Design Review Report – Item 1

Local government:	City of Stirling	
Item no.:	Item 1 – DA23/0802 – 92 Princess Road, Balga – Development Assessment Panel – Form 1 – Child Care Premise	
Chairperson:	Emma Williamson	
Panel members:	Anthony Duckworth Peter Damen Jackson Liew	
Local government officers:	Dean Williams Karina Bowater Simone Palmer Kelly Douglas	Acting Coordinator Planning Senior Planning Officer DRP Support Officer Client Liaison Officer
Observers		
Date:	2 November 2023	Time: 2pm
Venue:	City of Stirling – Challenger Room

Design quality evaluation Item 1 – DA23/0802 – 92 Princess Road, Balga – Development Assessment Panel – Form 1 - Child Care Premises DRP Meeting – Thursday 2 November 2023 and 3 August 2023	
	<i>Design Principle satisfied</i>
	<i>Design Principle pending further attention</i>
	<i>Design Principle not satisfied</i>
Principle 1 Context and character	<i>Good design responds to and enhances the distinctive characteristics of a local area, contributing to a sense of place.</i>
	<p>1a. The Panel discussed the importance of the proximity of the proposal to the neighbourhood centre, the opportunity to link with this and the impactful nature of the corner site.<

ROOF PLAN

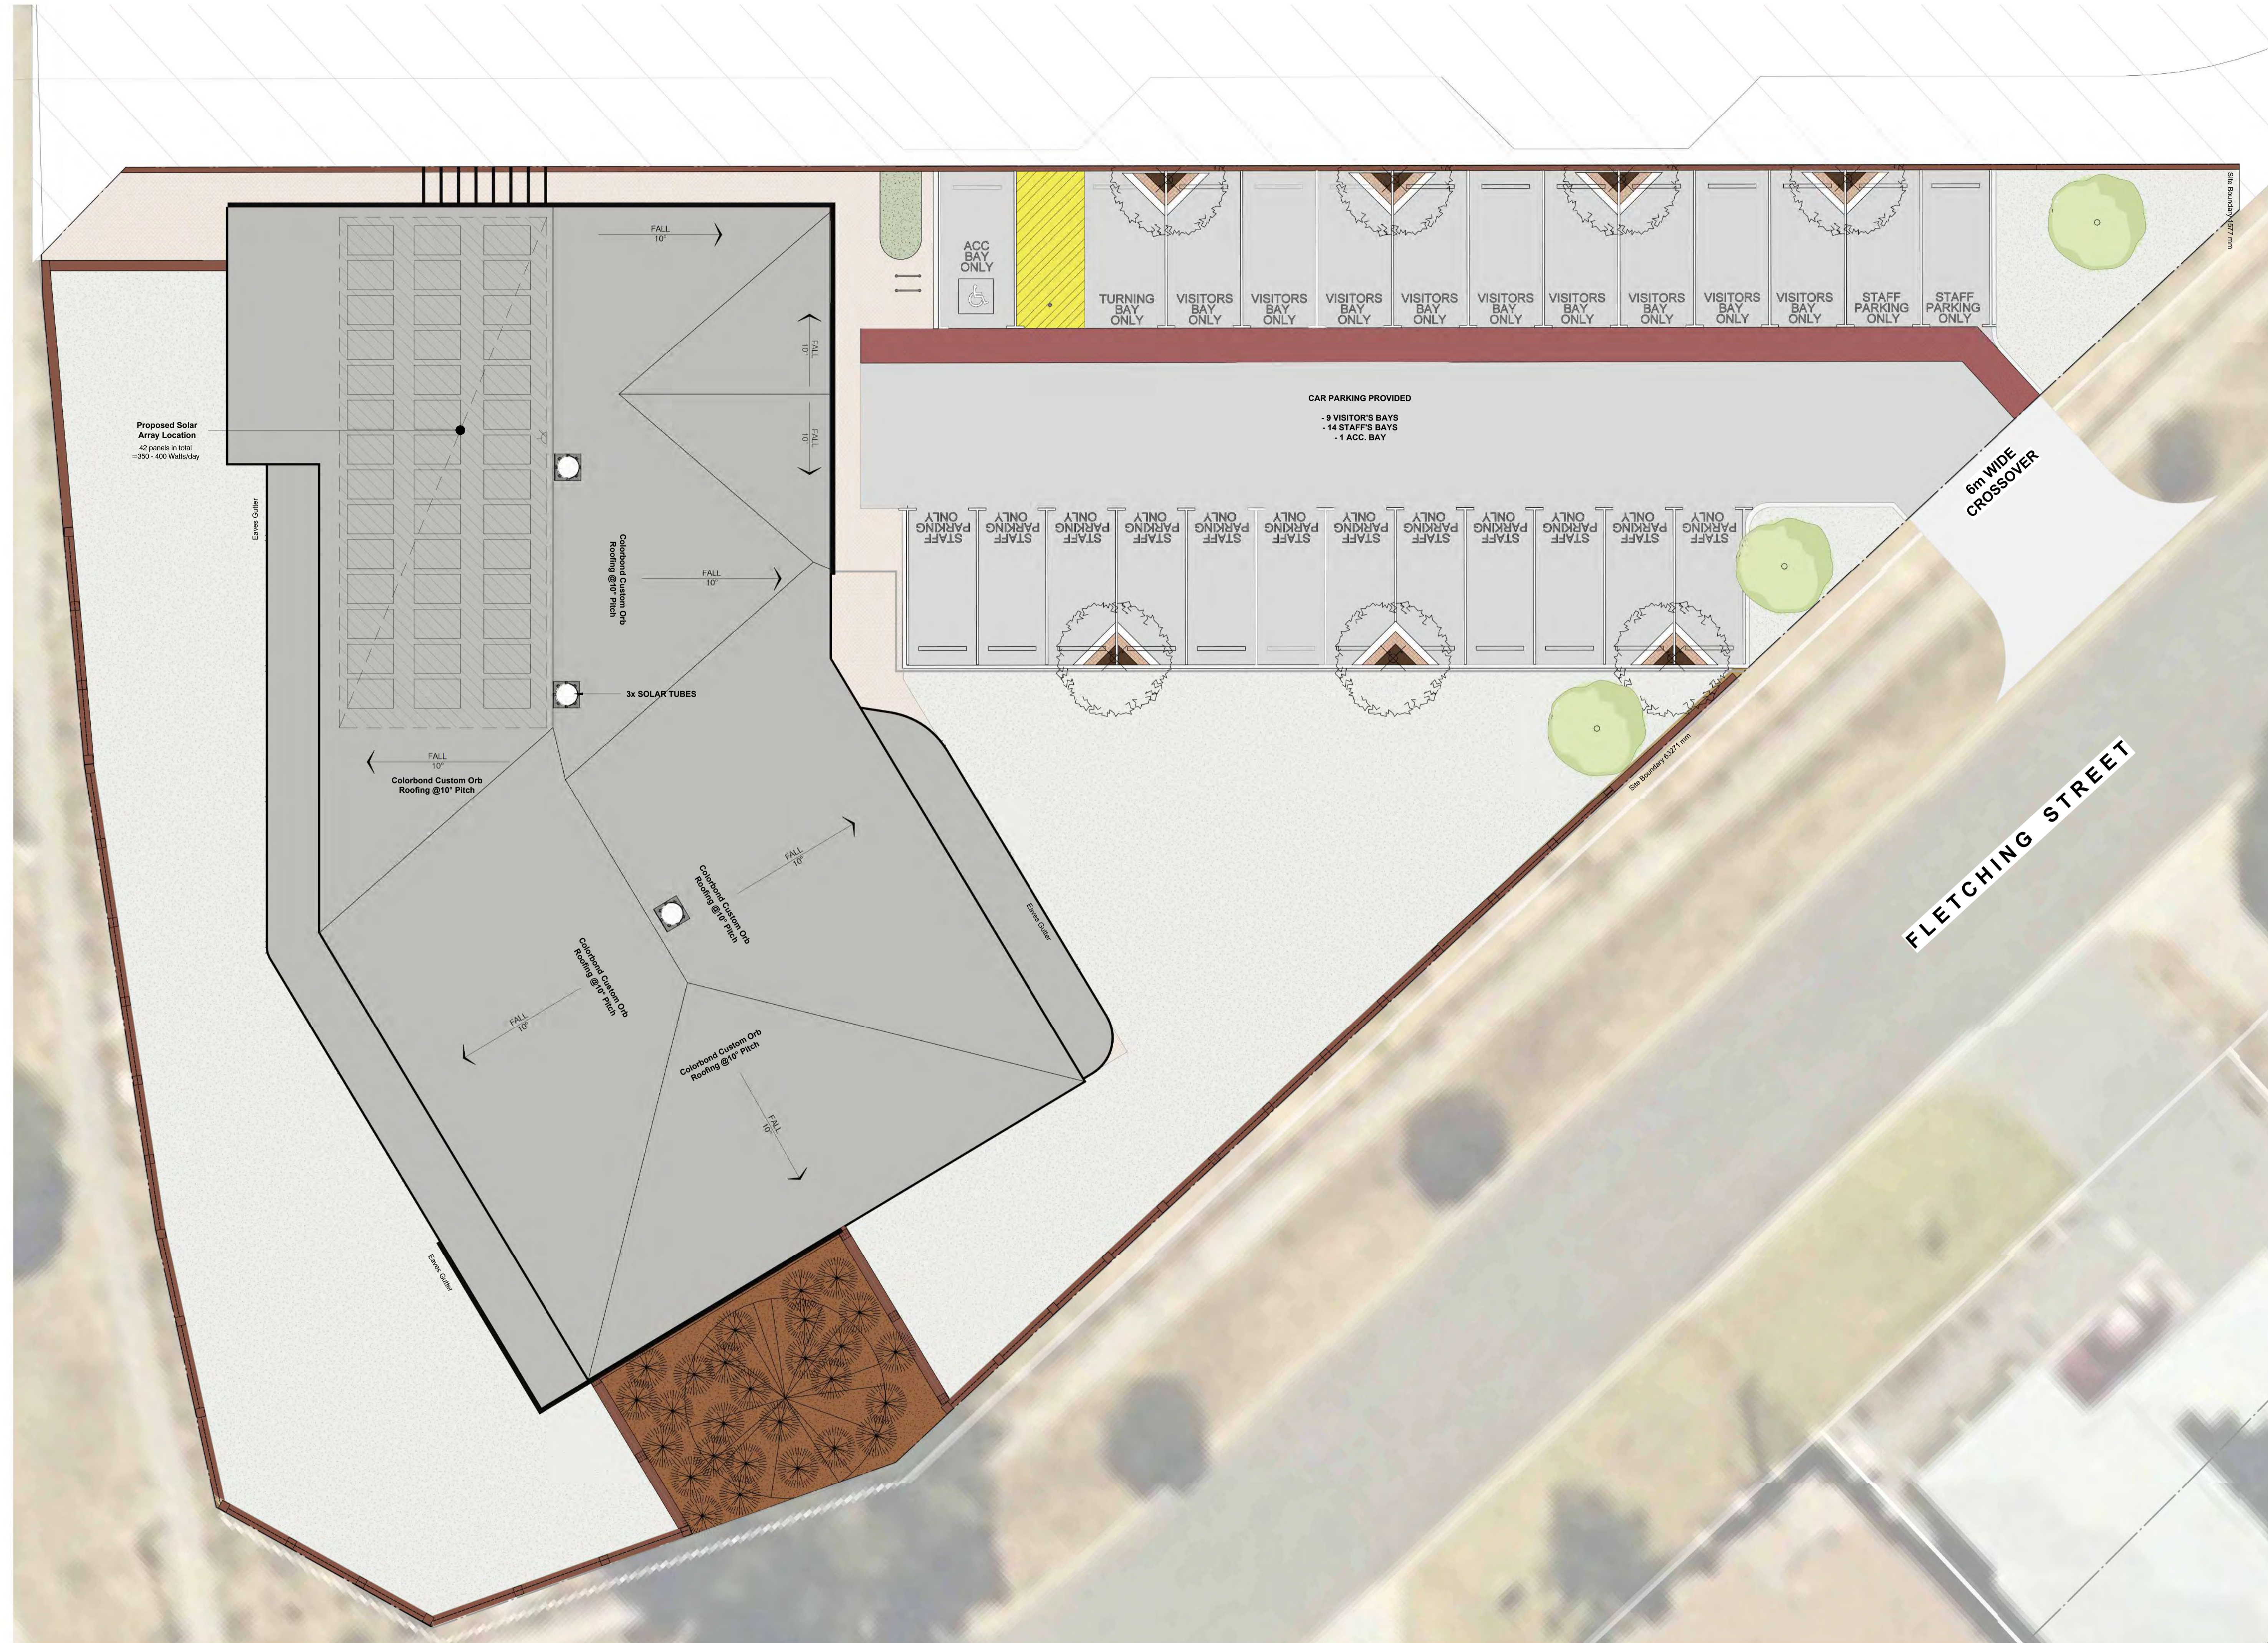
<p>area that is now outside the fence line of the childcare centre, but within the lot boundary, requires clarification in terms of resolution and maintenance.</p> <ol style="list-style-type: none"> 2. The Western Elevation of proposal is not considered to be sufficiently shaded. 3. The roof form needs simplification, to break the bulk and distinguish itself from a resident language. 4. The legibility of the pedestrian entry from Princess Road needs refinement. 5. Information in relation to material specification and detail is requested for the fencing and retaining. <p>Refer to attached Design Quality Evaluation Report.</p>
Chairperson signature

<p>simplified roof form at the point where the plan cranks could offer an opportunity to increase in height in the southern portion of the building. This would benefit the scale of the building and its corner address. Additionally, it would provide an opportunity for light to internal spaces through clearstory windows.</p> <p>3c. The Panel commented on the opportunity of the refinement of the roof form to increase shade on the western elevation and create a singular form that captures all of the building elements through an exploration of the pavilion and verandah typology.</p> <p>3d. The Panel commented on the importance of the legibility of the pedestrian entry and the need for the building language to respond to this. In recognizing the challenges of the site levels and future development of the neighbouring site the northern entry point is supported.</p> <p>3e. The Panel note that the presentation supplied and reviewed prior to DRP2 differs from the presentation presented by the Applicant. Importantly, the northern pedestrian entry is not noted on the plan (the door access is missing), and the fencing is indicated to have large translucent panels rather than the palisade fencing discussed.</p> <p>3f. The Panel support the direct pedestrian access from Princess Road and commented on the need for further development of this, ensuring the scale of the opening is maximised.</p> <p>3g. The Panel support the Applicant presentation that incorporates palisade fencing throughout the development. The Panel do not support translucent panels and do not consider this to meet the standard of good design.</p>

<p>Principle 10 Aesthetics</p>	<p><i>Good design is the product of a skilled, judicious design process that results in attractive and inviting buildings and places that engage the senses.</i></p>
	<p>10a. The Panel stated that simplification of the roof is necessary to support the aesthetics of the project.</p> <p>10b. The Panel note the extent of fencing and the significant impact this will have on the aesthetics of the proposal as it interfaces with the context. As the information in relation to the fencing differed between the presentation supplied for review and what was presented on the day confirmation of the fencing detail and material is requested. The Panel support the Applicant description of palisade fencing and the use of timber and request confirmation of the detail of this.</p> <p>10c. The Panel question the need for the architectural feature proposed at the southern end of the building if a simplified roof form and gable end are pursued.</p> <p>10d. The Panel note the successful combination of form and materials depicted in sheet 13 of the supplied presentation and encourage the Applicant to further develop this approach.</p>

North West Fencing Elevation
SCALE: 1 : 100

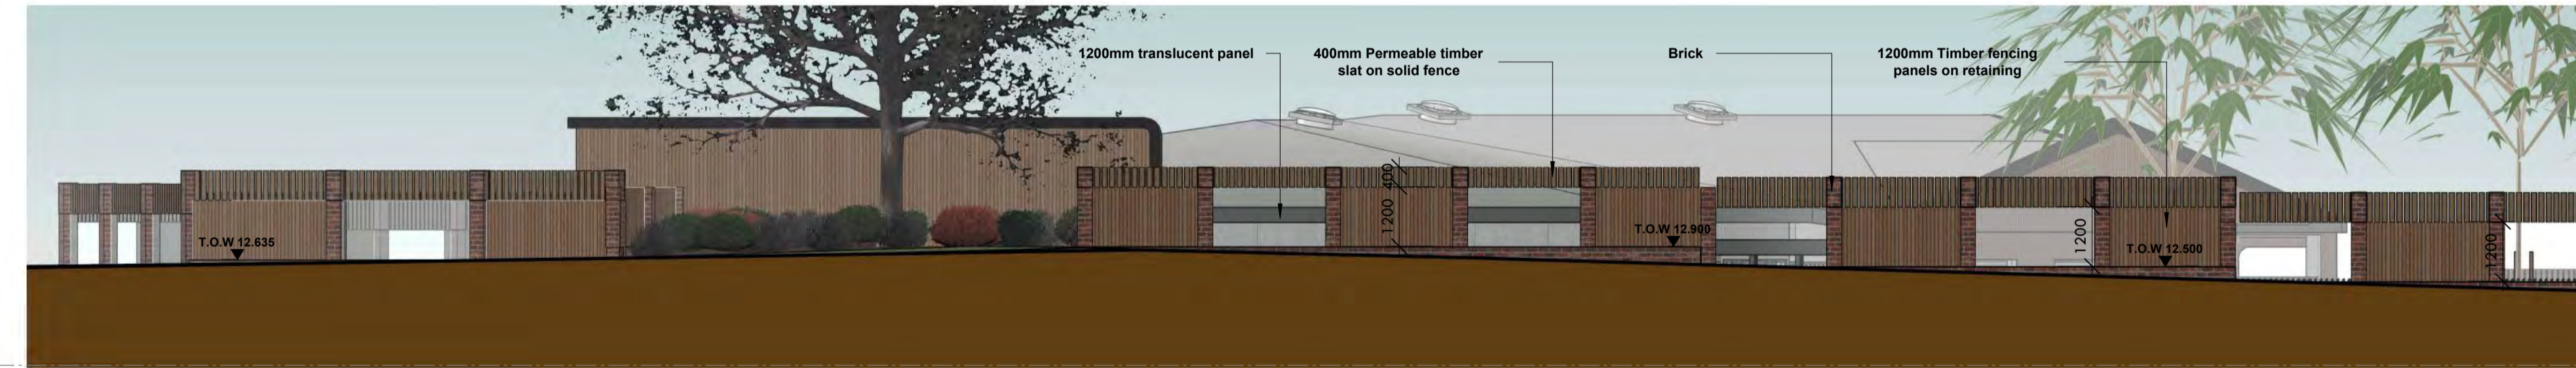
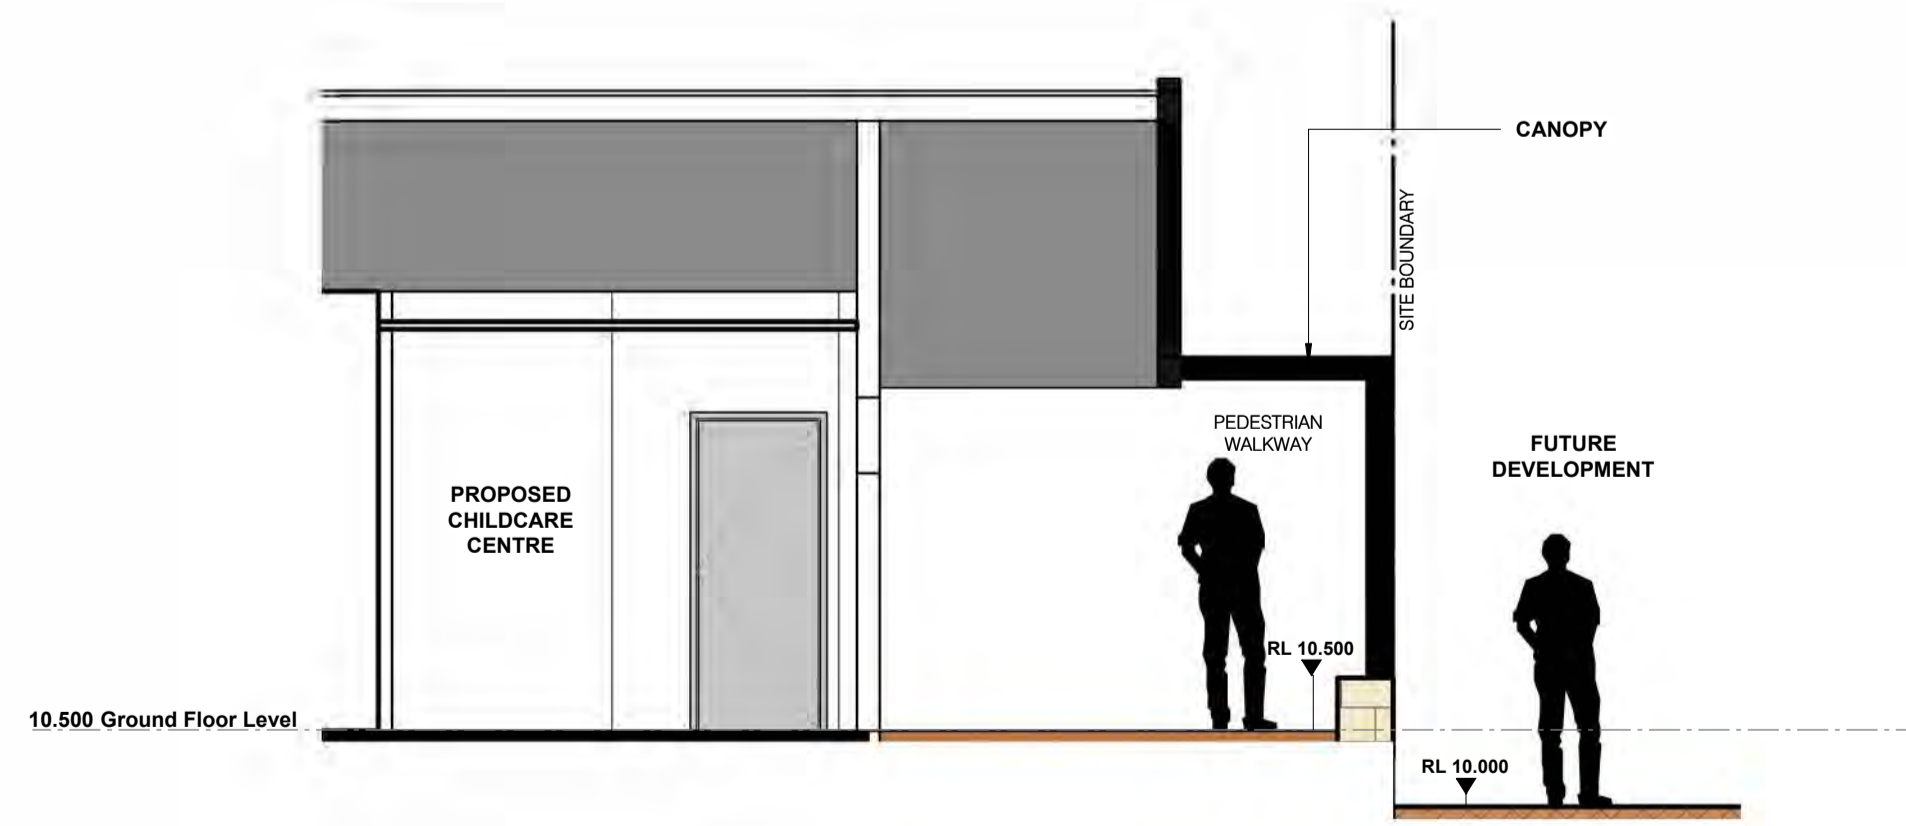
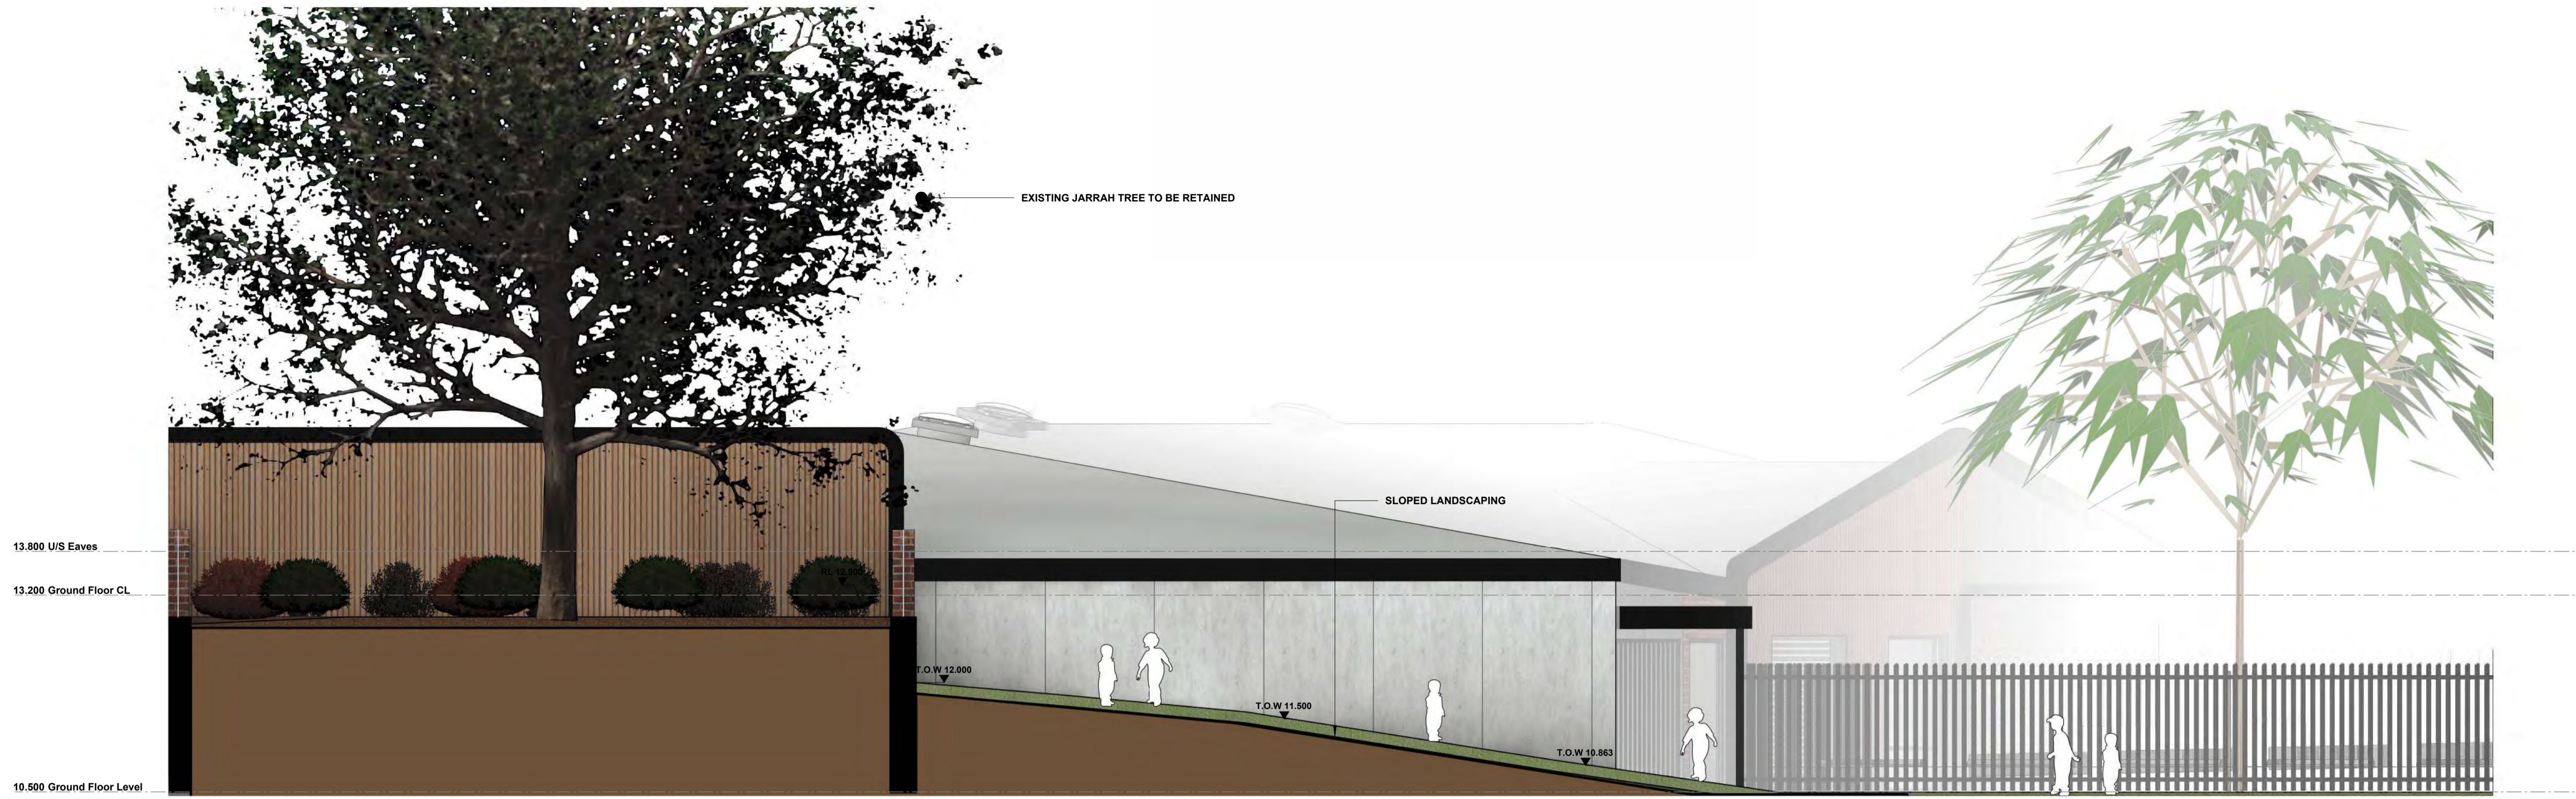
<p>3a. Concern was expressed by the Panel around the dominance of the fencing and retaining which requires resolution. The Panel recommends the development of the fence to incorporate visual permeability and material articulation.</p> <p>3b. The Panel stated that the retaining walls are a part of the design response and as such should be included on the drawings. More information and clarity around the retaining wall is required.</p> <p>3c. The Applicant was encouraged to consider the importance of pedestrian connectivity on each street. This has not been addressed and the single pedestrian entry through the car park is not supported by the Panel.</p> <p>3d. The Panel commented on the impact of the retaining wall and fence, which results in the building appearing small in scale. The</p>	<p>3a. Fencing has been reviewed for visual permeability and materials. Recycled brick piers, retaining walls, timber solid fencing and palisade fencing have been included. Solid fencing and wall required by Acoustic consultant.</p> <p>3b. In addition, the height of the fencing has been reviewed by an acoustic consultant and we reduced the fencing height which increased permeability, however areas required solid panels. The fencing reflects new and recent styles in close proximity. The roof form has been adjusted to afford more prominence to the building at the south western corner.</p> <p>3c. Pedestrian connectivity has been revised by adding a pedestrian path to the main entry from the West.</p>	<p>3a. The Panel reiterated the comment from DRP1 in relation to the bulk of the building that results from the current roof form. The roof is considered overly complex, with the form relying too heavily on a residential typology. The Panel suggest a simplification of this to strengthen the language and incorporate additional shading to the western elevation. The Panel commented on the success of the gable end and encourage the applicant to use this to drive a more simplified form that has the characteristics of a pavilion rather than an oversized dwelling.</p> <p>3b. The Panel maintain their concern that the topography of the site limits the legibility of the building from the street. As a result of the site levels proposed, and the natural ground level, the building</p>

<p>9b. Comment was made by the Panel the street interface requires further thought and development. The Applicant was encouraged to look at how the retaining wall and boundary fence could activate the streetscape. The current approach is not supported.</p> <p>9c. It was stated by the Panel the public art policy applies in this area and the Applicant was encouraged to demonstrate and integrate the public art into the design.</p>	<p>9b. Retaining walls and fencing have been reviewed and redesigned to create an improved interface.</p> <p>9c. Public Art is proposed to be located on the north-west fence, a prominent corner of Princess Road.</p>	<p>9a. The Panel support this design principle.</p>	
<p>10a. The Applicant was encouraged to think about the impact of the shade structures and stated there is opportunity for increased material articulation.</p>	<p>10. SW corner amended, northern elevation and entry adjusted. Recycled brick and darker fascias added. Shade Structures can be seen</p>	<p>10a. The Panel stated that simplification of the roof is necessary to support the aesthetics of the project.</p> <p>10b. The Panel note the extent of</p>

<p>10b. Comment was made by the Panel the design of the building is hard to appreciate as it is screened by the boundary fence. Resolution of this requires a consideration of scale and articulation to break the building bulk.</p> <p>10c. The Panel suggested looking for visual references for design detail such as the suggested double columns.</p>	<p>on the landscaping plan as part of the playscape. The boundary fence has been adjusted to be more permeable.</p>	<p>fencing and the significant impact this will have on the aesthetics of the proposal as it interfaces with the context. As the information in relation to the fencing differed between the presentation supplied for review and what was presented on the day confirmation of the fencing detail and material is requested. The Panel support the Applicant description of palisade fencing and the use of timber and request confirmation of the detail of this.</p> <p>10c. The Panel question the need for the architectural feature proposed at the southern end of the building if a simplified roof form and gable end are pursued.</p> <p>10d. The Panel note the successful combination of form and materials depicted in sheet 13 of the supplied presentation and encourage the Applicant to further develop this approach.</p>
